# SONY car stereo Service Bulletin No.80

**Model:** CDX-5/R7

**Date:** September 4, 1987

**Subject:** Syscon/Mechanical Control IC  
 Compatibility

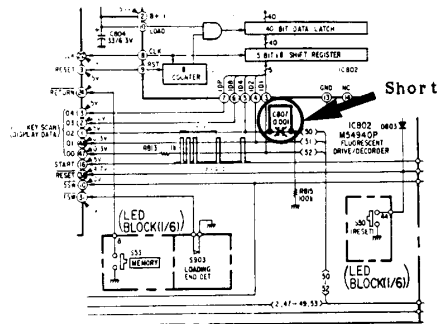
Only the most current control ICs are available from KCP. When replacing the original ICs with the updated ones, the following modifications must be done.

1. When replacing a 276M with a 378M, C807 must be shorted.

2. When replacing a 303M with a 378M, change the value of C566 from 330 $\mu$ F to 0.47  $\mu$ F.
